# PHY Configuration

## RF Channel Definition

PHY-0Link Spectrum Ad Hoc

## Slide 19

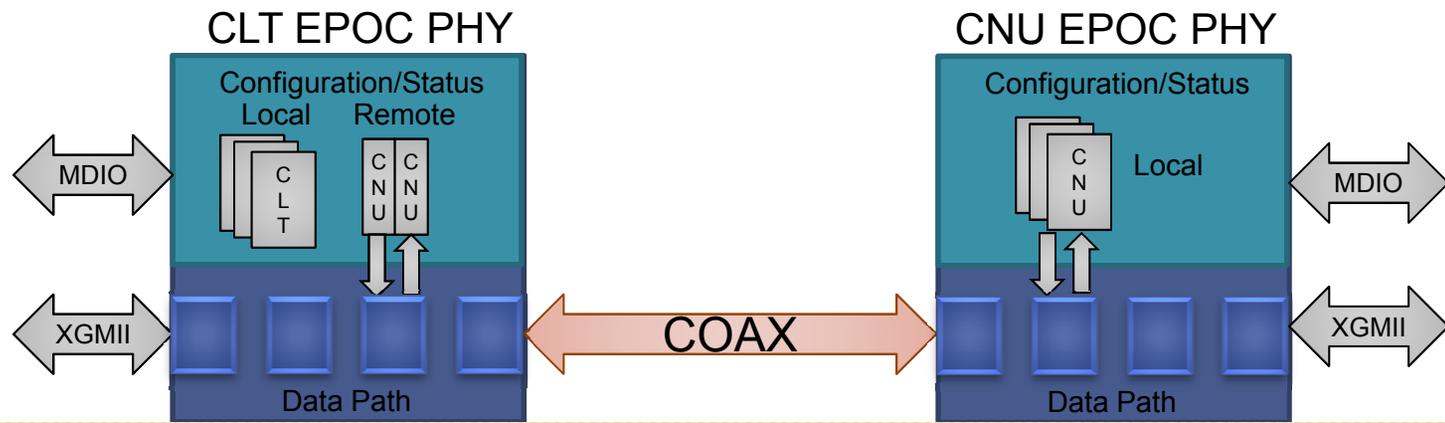
- EB17** Exclusion Band Start Carrier Number and Count  
Edward Boyd, 1/30/2013
- EB18** Downstream PHY Link Location is needed as well.  
Edward Boyd, 1/30/2013
- EB19** The PHY Link Channel should configure this parameter.  
Edward Boyd, 1/30/2013
- EB23** This is a hunting procedure.  
Edward Boyd, 1/30/2013
- EB24** What is primary. I would say remotely configured via PHY Link Channel.  
Edward Boyd, 1/30/2013
- EB25** DS Frequency of all RF Channels  
Edward Boyd, 1/30/2013
- EB26** I'm not sure about width. US PHY Link Channel Definition  
Edward Boyd, 1/30/2013
- EB27** I think that it will be a fixed width but we haven't passed a motion on it yet.  
Edward Boyd, 1/30/2013
- D6** I think th eDS PHY-Link (at least in the primary RF channel should be defined by standard or discovered. I agree that it wouldn' hurt to reinforce it via configuration.  
D00725987, 2/5/2013
